BEFORE THE ADMINISTRATOR
U.S. ENVIRONMENTAL PROTECTION AGENCY

Consolidated Environmental
Management, Inc./Nucor Steel, Louisiana
To construct and operate a Pig Iron and Direct
Reduction Iron manufacturing facility in
Convent, St. James Parish, Louisiana

Permit No.: 2560-00281-V1 (modified pig
iron process Title V permit)
Permit No.: 3086-V0 (DRI Title V)
Permit No.: PSD-LA-751 (DRI PSD)

**PETITION REQUESTING THE ADMINISTRATOR TO OBJECT TO
TITLE V OPERATING PERMITS NOS. 2560-00281-V1 AND 3086-V0
ISSUED TO CONSOLIDATED ENVIRONMENTAL MANAGEMENT, INC. / NUCOR
STEEL LOUISIANA**

Figure 1: Carbon emissions coefficient vs. energy content in U.S. pipeline-grade natural gas

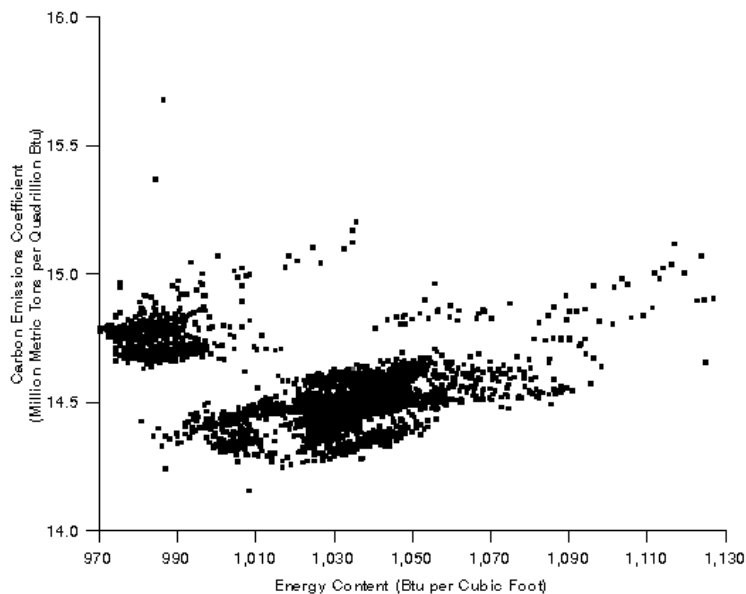
This calculation procedure must account for the fact that the carbon content and heating values of pipeline-grade natural gas can show considerable variation over space and time, as shown in Figure 1.

The U.S. Department of Energy (“DoE”) reports CO₂ fuel efficiency coefficients for pipeline natural gas ranging from 54.01 kg CO₂/MMBtu (5.401 kg CO₂/therm) at a higher heating value (“HHV”) of 975-1,000 BTU per cubic foot (“Btu/scf”) of natural gas to 53.72 kg CO₂/MMBtu (5.372 kg CO₂/therm) at an HHV of 1,075-1,100 Btu/scf.²⁵ Given this variability in fuel composition, facility-specific values for carbon content and heating value should be used to determine GHG emissions from natural gas combustion wherever possible. This information should be available from suppliers or Material Data Safety Sheets for the purchased fuel and should be confirmed with fuel analysis results.

Subpart Q for iron and steelmaking from the promulgated Mandatory Reporting of Greenhouse Gas rule does not provide a calculation procedure for DRI production and the reference is therefore moot. Therefore, EPA must require LDEQ to develop a calculation procedure for DRI production and present it for public review.
